DL MIMO Structure

IEEE C80216m-08/860

TGm, DL_MIMO RG – Call for comment of final draft : SDD Text on Downlink MIMO Schemes (IEEE 802.16m-08/657r2)

Comment for MIMO structure

MCW with limited number of codeword and stream permutation

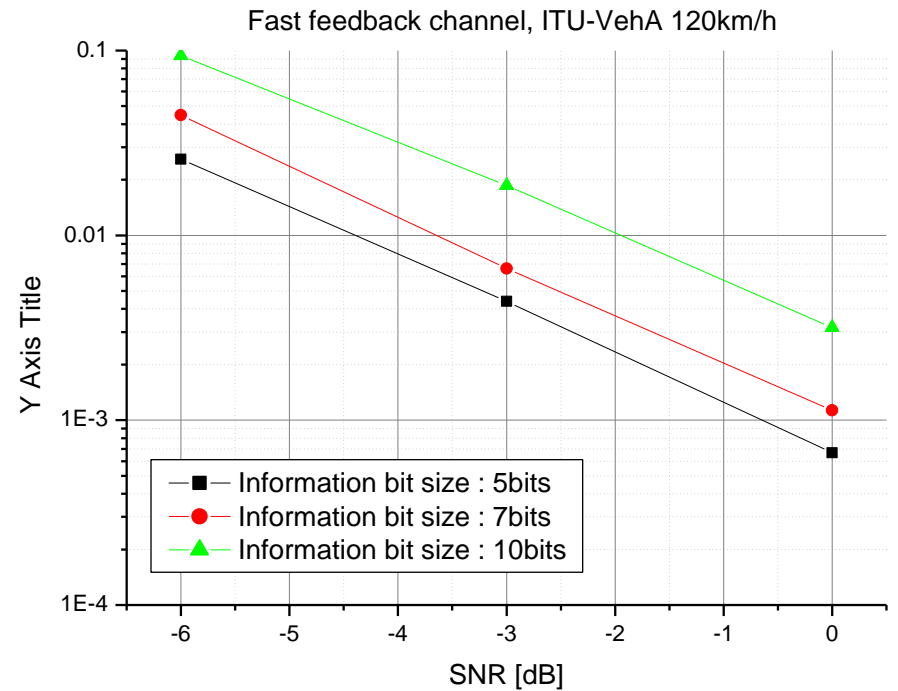
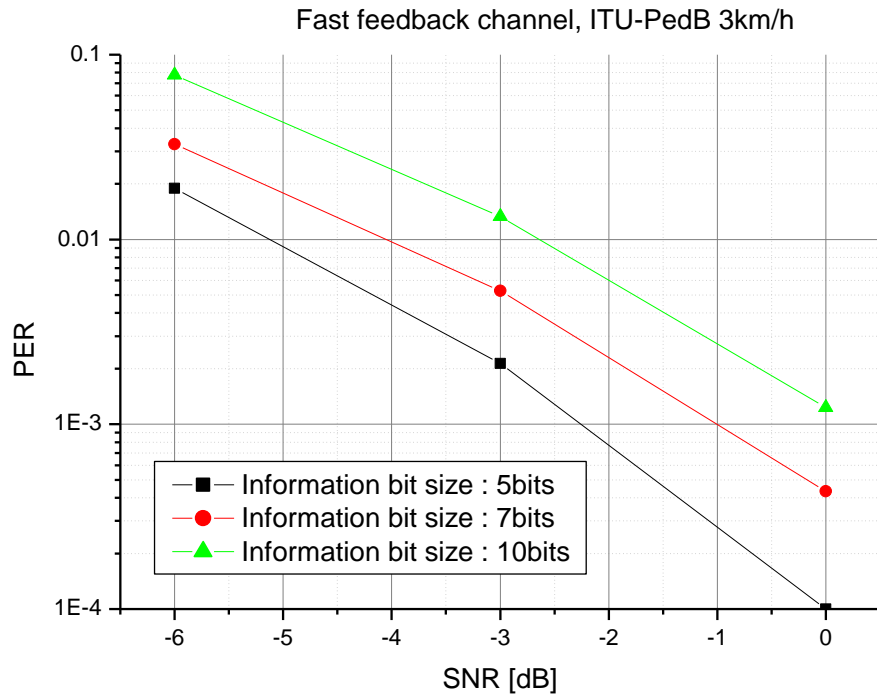
- MCW with limited number of layer is between SCW and pure MCW
 - Pros : Per layer link adaptation can be applied, layer level SIC receiver can be applied, partial spatial diversity can be achieved
 - Cons : Medium feedback overhead is required
- MCW with stream permutation
 - Stream permutation makes averaging all layers
 - Same feedback overhead compare with SCW structure when MS receiver type is MMSE or MLD
 - When SIC type of receiver is applied, feedback overhead is effectively reduced (Compare with MCW without stream permutation)
 - SINR for second layer is always “SINR for first layer + delta” (positive value)
 - Full spatial diversity can be achieved (Same as SCW)
 - Layer level SIC receiver can be applied (Same as MCW)
